RE: PROPOSED RESIDENTIAL DEVELOPMENT – 86 KEONA ROAD, MCDOWALL
TRAFFIC ENGINEERING RESPONSE TO COUNCIL INFORMATION REQUEST

This letter has been prepared in response to Brisbane City Council's (BCC) Information Request dated 20th May 2026 (Ref: A007008486). The Information Request is in relation to a Reconfiguring a Lot (RAL) application for a proposed residential subdivision for one (1) lot into 13 residential lots located at 86 Keona Road, McDowall, QLD 4053 which is formally known as Lot 2 on SP127997.

Title:
RCV TURNAROUND AT T-HEAD
SWEEP PATH ASSESSMENT

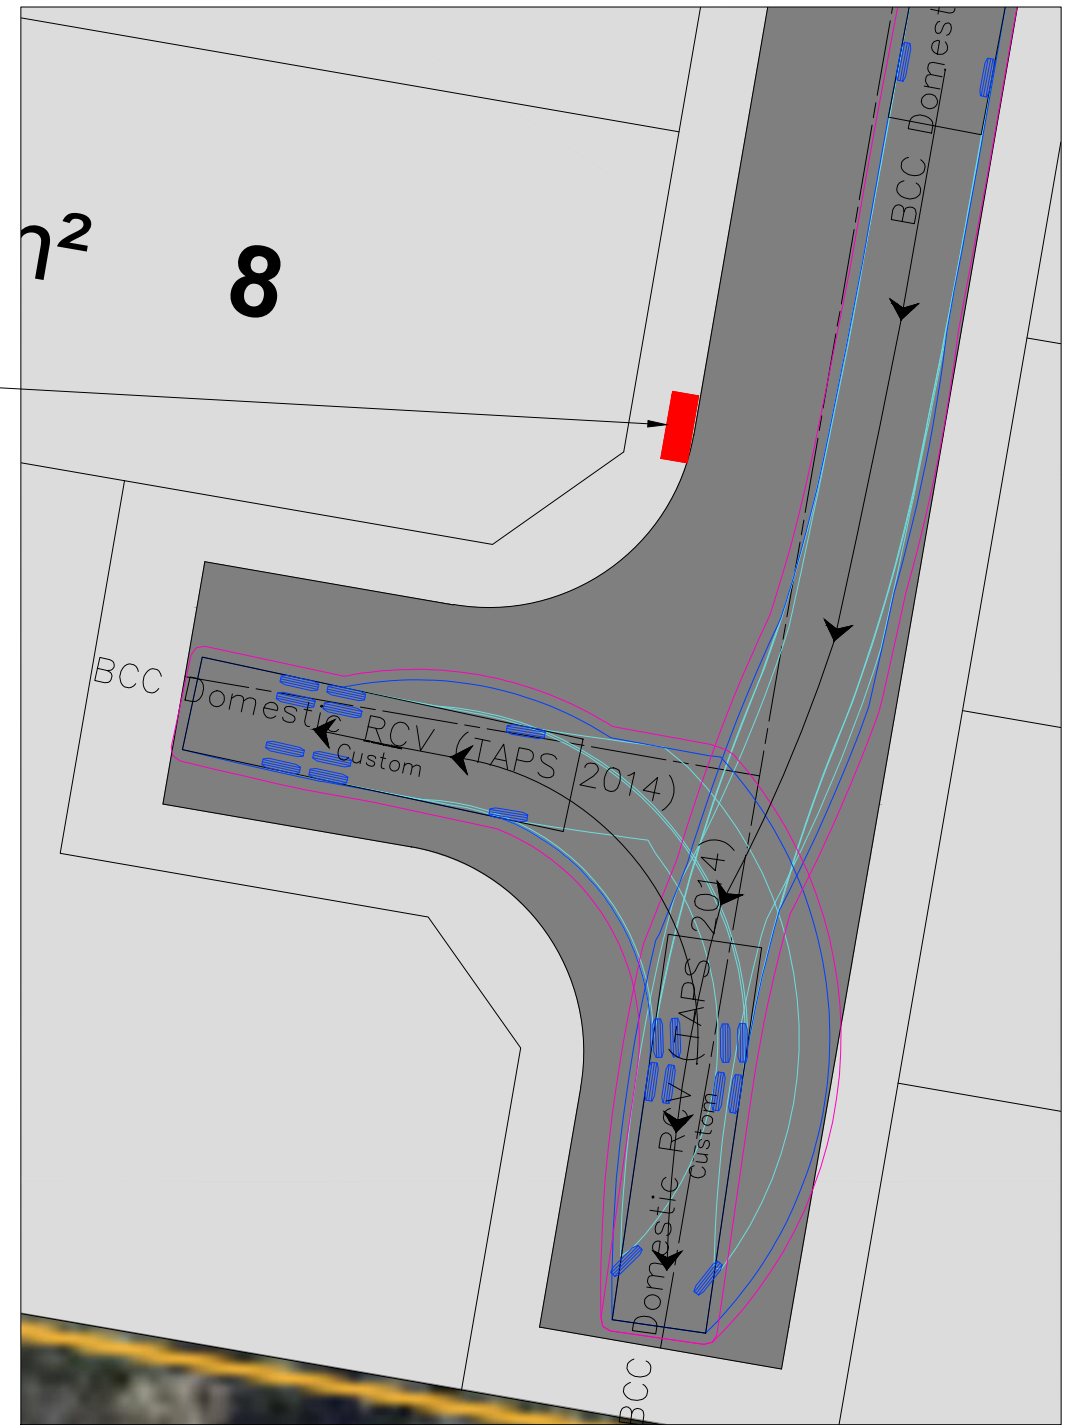
7. *Kerbside collection of the mobile garbage bins (MGBs) presented at the Keona Road kerbside at the frontages of Lots 12 & 13 is supported in principle. The internal swept path diagrams demonstrate that a side loading RCV is able to turn around within the site of the private road. However, the left of the RCV (with the lifting arm) is never presented to the frontage of Lot 7, therefore, the 2 x MGBs for Lot 7 will need to be presented on the frontage of Lots 6 or 8 (preferred) in accordance with PO8 of the Infrastructure design code*
 - a) *Provide amended plans to show the bin presentation/ collection point for Lot 7.*

As per the BCC request, a bin collection location is to be provided for Lot 7 at the preferred Lot 8 frontage. This nominated bin collection location for Lot 7 is indicated in the swept path assessment included in Attachment 1. This location has been selected as it ensures the left-hand side of the RCV is appropriately aligned with the MGB's at the time of collection whilst being on the straight section of the internal private road as demonstrated in the swept path assessment. This location also ensures sufficient space is available for the future crossover provision for Lot 8 on this frontage. The bin pad dimensions have been designed in order to adequately provide space for two (2) 120L bins for Lot 7.
